**Architectural Design Review Board**  
**March 21, 2023 @ 4:00 p.m.**  
Council Chambers  
First Floor, 345 High Street  
Hamilton, Ohio 45011

**To:** Architectural Design Review Board  
**From:** Dani Baxter  
**Subject:** **New Business - AGENDA ITEM #1**  
**244 Main St – New Addition to Existing Structure**  
Steven Gebhart, Applicant  
Meeting Date: March 21, 2023  
Received Application: February 27, 2023  
**Impacts:** Rossville-Main Historic District

**NORTH ELEVATION**  
SCALE: NONE

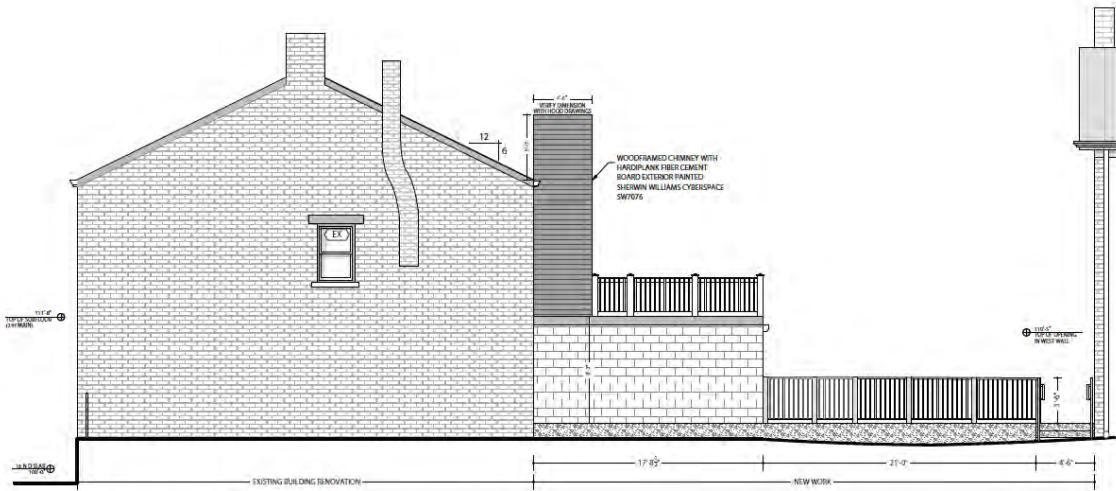
- Size of vent hood as presented is the maximum size estimated. Vent hood may be smaller once equipment manufacturer and other City Department requirements are reviewed.
- Applicant is proposing hardy plank as opposed to matching brick due to the cost of brick.
- Fretboard Brewing and Public House on Main St has a similar addition with non-matching materials.
- Previous ADRB approval regarding CMU/brick single story addition heard on July 5, 2022 has not been modified.
- Mural design has not been finalized.

The ADRB may approve, modify, or deny the COA request as presented to the Board. Planning Department staff has prepared the following motions for the Board's consideration:

**EX/DEMO NORTH ELEVATION**  
SCALE 1/4" = 1'-0"

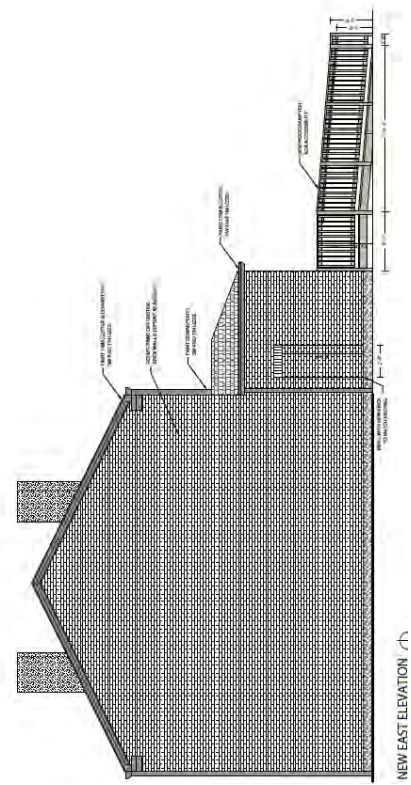
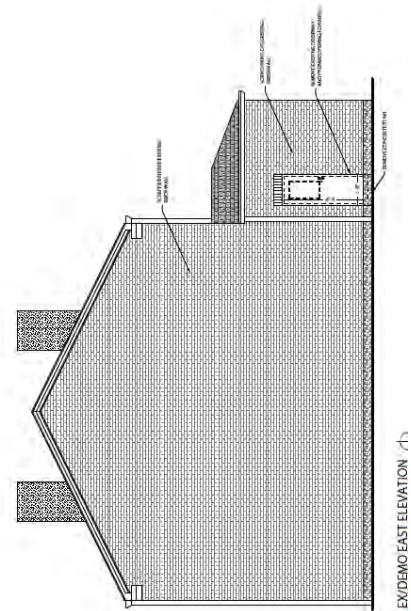
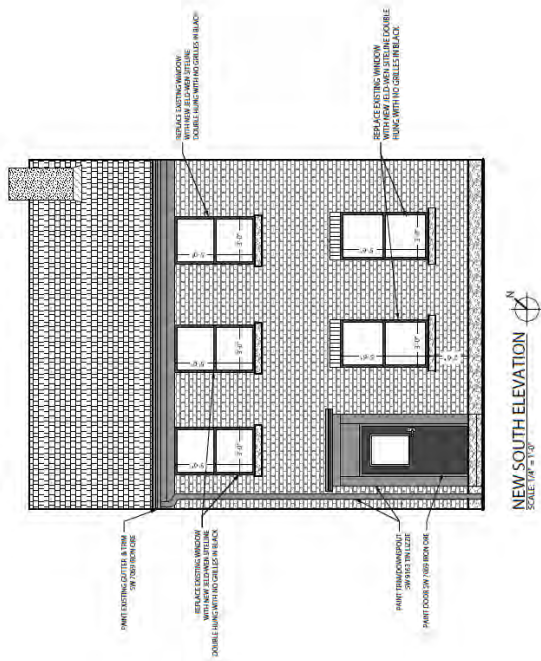
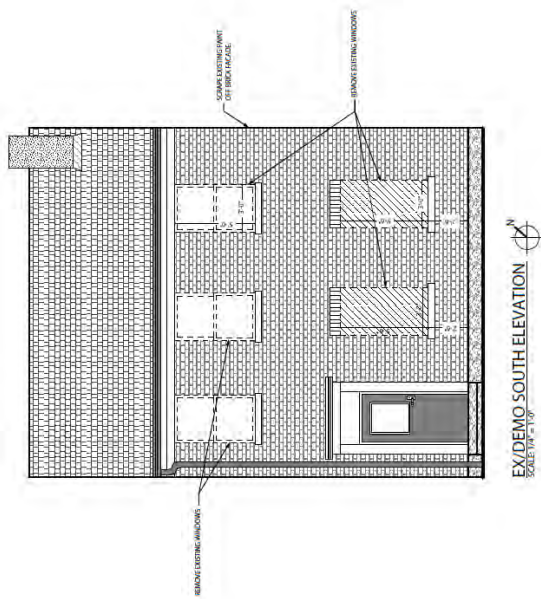
- Planning Department staff met onsite with property owner (Dale Wurzelbacher). Mr. Wurzelbacher indicated that the proposed ADA ramp on the site plan is going to be reoriented.
  - New doorway to be installed along south side of cinder block addition.
  - Three (3) remaining doorways in rear of home to be filled in.
  - Staff recommended that if the ADA ramp is relocated to a new entryway the door it was originally supposed to access, along the northwest side of original building, should become a window and not filled with brick. Property owner seemed open to this idea.
- Staff recommends salvaging the two windows located along the stairway. They are unique in size and appear to be in good condition.

- ADRB move to approve the COA request to replace all the existing original historic wood windows on the primary residence with JeldWen Sitrine windows (minus the two smaller windows along the stairway), infill rear doorways with matching material, and install new doorway off cinderblock addition as proposed after determining it maintains compliance with Section 2600 of the Hamilton Zoning Ordinance and ADRB Policies & Guidelines.
- ADRB move to deny the COA request as proposed, as it is not compliant with Section 2600 of the Hamilton Zoning Ordinance and/or ADRB Policies & Guidelines.

**A1 NORTH ELEVATION**

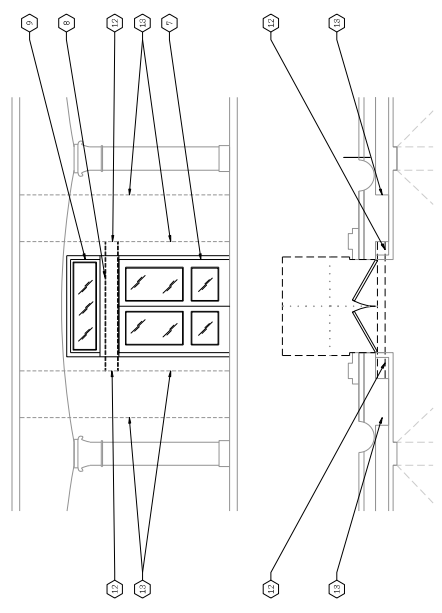
- Proposed basement, front façade window removal-
  - Six basement windows to be removed and infilled.
  - Infill Material- New eight (8) inch CMU infill, grouted solid. Exterior face CMU. Provide Quick-Crete sand mix finish coat. Paint to match existing stone. Finish face shall be recessed two (2) inches from exterior face of existing stone.

- ADRB move to approve the COA request to replace the existing basement windows, remove six (6) basement windows and two (2) rear faced windows, in addition to installing new front and rear doors as proposed after determining it maintains compliance with Section 2600 of the Hamilton Zoning Ordinance and ADRB Policies & Guidelines.
- ADRB move to deny the COA request as proposed, as it is not compliant with Section 2600 of the Hamilton Zoning Ordinance and/or ADRB Policies & Guidelines.
